AMENDMENTS TO THE DRAWINGS:

R E M A R K S

Fig. 3

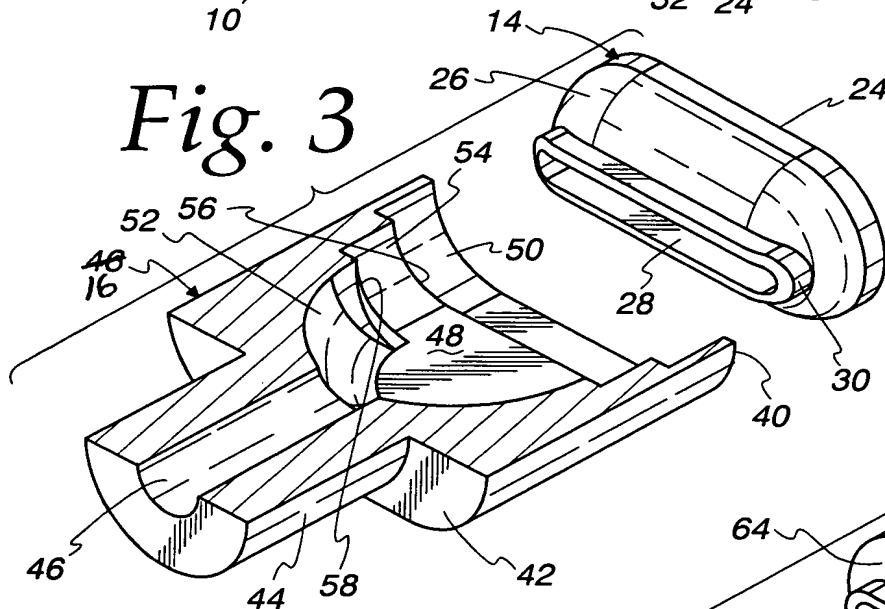
The attached sheet of drawings includes changes to Fig. 3. This sheet, which includes Figs. 2-4, replace the original sheet including Figs. 2-4. In Figure 3, the correction changes reference number 46 to reference number 16 to indicate the tank 16.

A replacement sheet has been submitted herewith and has been amended to change the reference character "46" to "16" to indicate the tank in Fig. 3. Accordingly, the objection to the drawings should be withdrawn.
